Service Bulletin

SB Number:	SB AS-121	Issue Date: 01/07/2003
Subject:	Application of grease to 'UPPER TURN PLATE' (J83)	
Model:	F-4730, DF-71E, DF-35

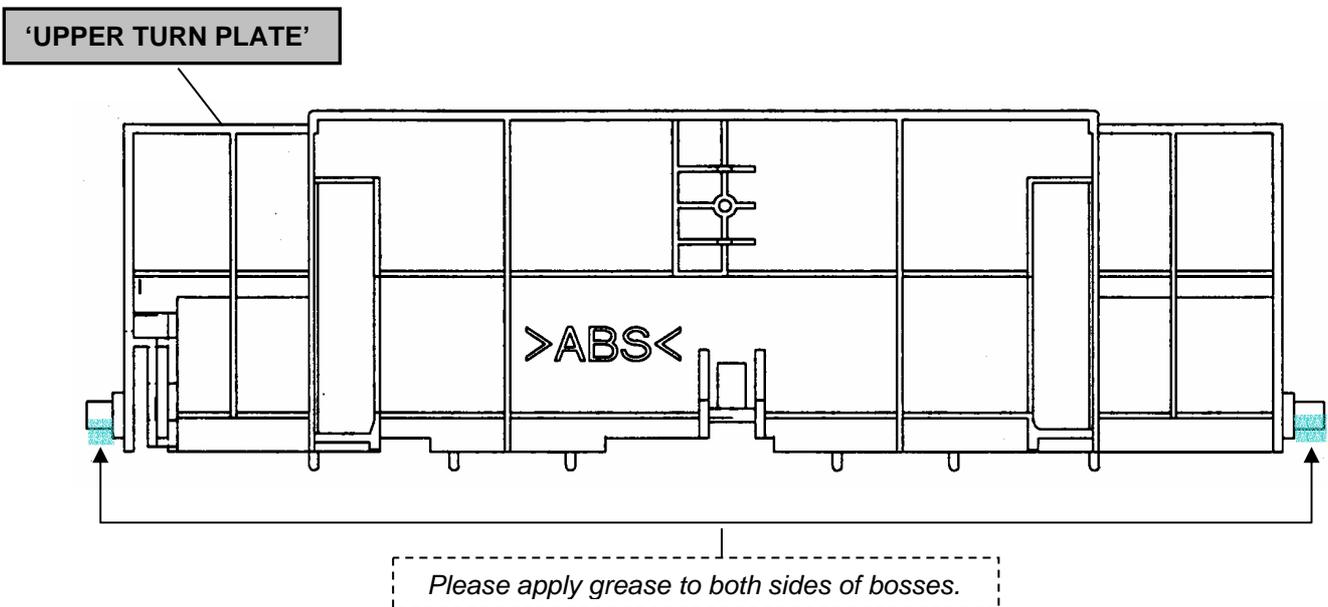
The 'UPPER GUIDE, FEED SHIFT' and the fulcrum of the 'UPPER TURN PLATE' may not rotate smoothly. As a result of the unsmooth rotation the parts are not stable and may vibrate (resulting into JAM 83) and possibly wear down.

To prevent the contact section on the 'UPPER GUIDE, FEED SHIFT' from wearing down, please apply grease (TMP 1 grease) to the fulcrums of the 'UPPER TURN PLATE'. See picture below.

(Quantity of grease: 2 pieces of rice grain)

Please take care that, except for the fulcrum of 'UPPER TURN PLATE', no grease adheres to the rest of the paper conveying route.
